PLANNING COMMISSION REPORT Public Hearing Item

FINAL DEVELOPMENT PLAN FOR BAUER FARM; XPRESS WELLNESS URGENT CARE; 4700 OVERLAND DR (MKM)

FDP-15-00108: Consider a Final Development Plan for Bauer Farm, Xpress Wellness Urgent Care Walk-In Clinic, located on approximately 1.4 acres, located at the northwest corner of 6th St. and Folks Rd. Submitted by Kerr 3 Design Group, Inc., for Free State Holdings, Inc., property owner of record.

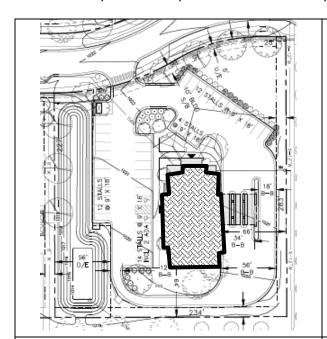
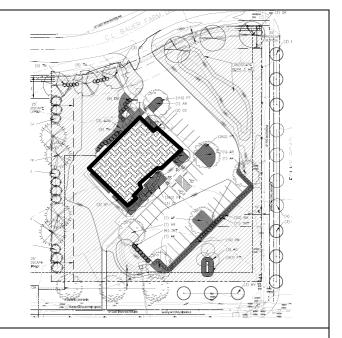
Figure 1 compares the lot layout on the approved Preliminary Development Plan (1A) and the proposed layout with the Final Development Plan (1B). The building is located in the center portion of the lot in each plan; however, the bank had an access drive adjacent to W 6th Street rather than the parking proposed in the Final Development Plan. The layout proposed in the Final Development Plan provides more landscaped greenspace near the intersection.

- 1) Change in use from a *Financial, Insurance, Real Estate Office use to a Health Care Clinic/Office* use.
- 2) Reduction of the overall building size from 5,000 sq ft to 4,280 sq ft.
- 3) Total off-street parking has been revised from '18 required and 42 provided' to '15 required and 30 provided'.
- 4) Removal of the drive-thru lane and slight reconfiguration of the building and parking area.
- 5) Reduction in the area of the stormwater detention pond.

Figure 3. Pedestrian walkway shown with dashed line.

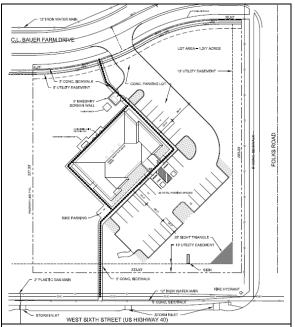
Drive and W 6th Street. The walkway provides access to all entrances into the building and to the mechanical equipment area on the north side of the building. (Figure 3)

BUFFER YARD LANDSCAPE SUMMARY

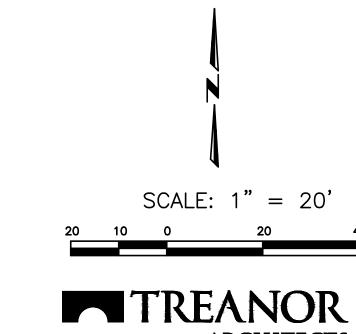
NORTH: This bufferyard is wider than 25 ft in width also. The north bufferyard is 214 ft long with approximately 27 ft of access drive for a length of approximately 187 ft. The bufferyard landscaping provided for the north bufferyard was approved through Alternative Compliance, taking into account the width of Bauer Farm Drive and the parking are to the north. This should be noted on the plan.

- 1. The final plat for the subject property, Bauer Farm Addition No 7, shall be recorded with the Register of Deeds, prior to the recording or release of the Final Development Plan.
- 2. Submission of revised Final Development Plan with the following change:
 - a. Addition of the following note to the Bufferyard Landscape Summary: "The landscaping provided for the Type 1 Bufferyard required on the north side of the property (adjacent to PRD Zoning) as shown on the plan has been approved through Alternative Compliance, taking into account the width of the Bauer Farm Drive Right-of-way and the parking area to the north."

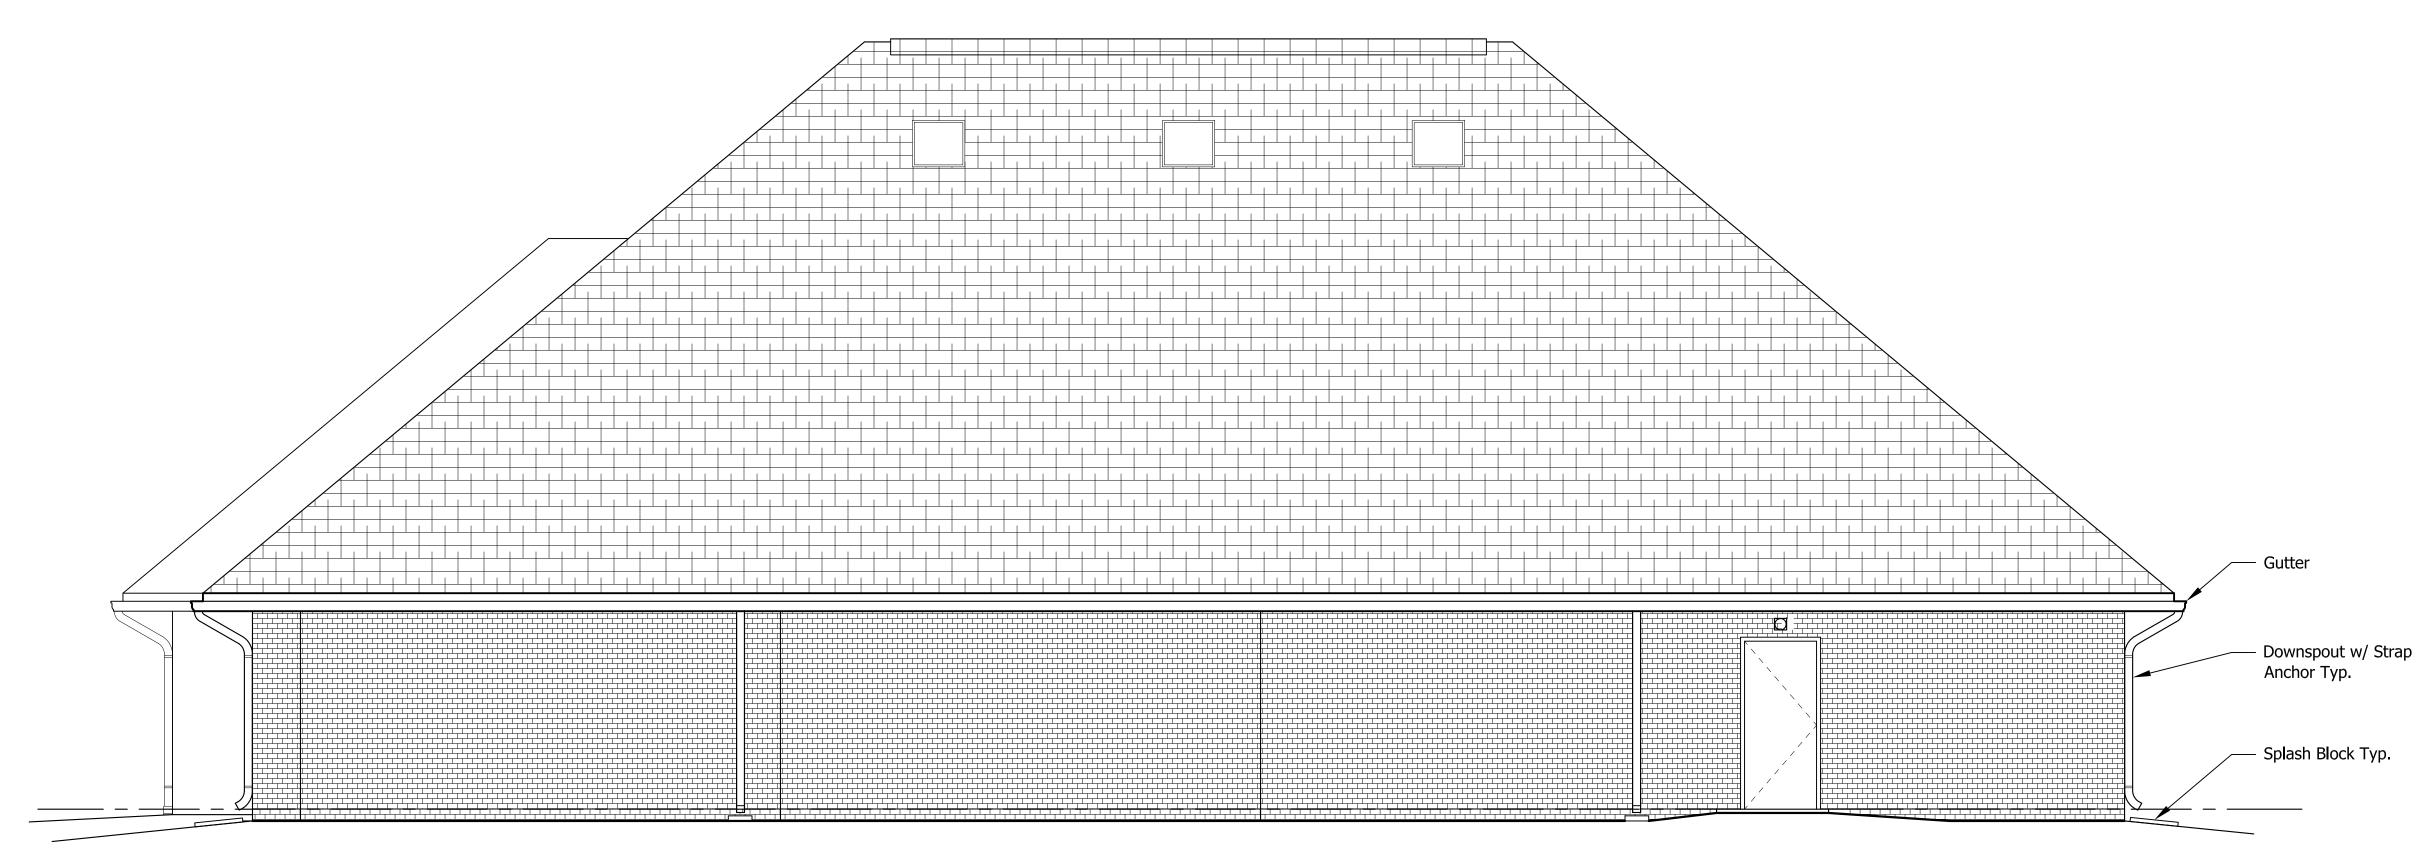
The façade to the east and north will also be visible from the public right-of-way (Figures 5 and 6). The east and north building facades have less detail than the south elevation; however the landscaping proposed along these facades should provide variety.
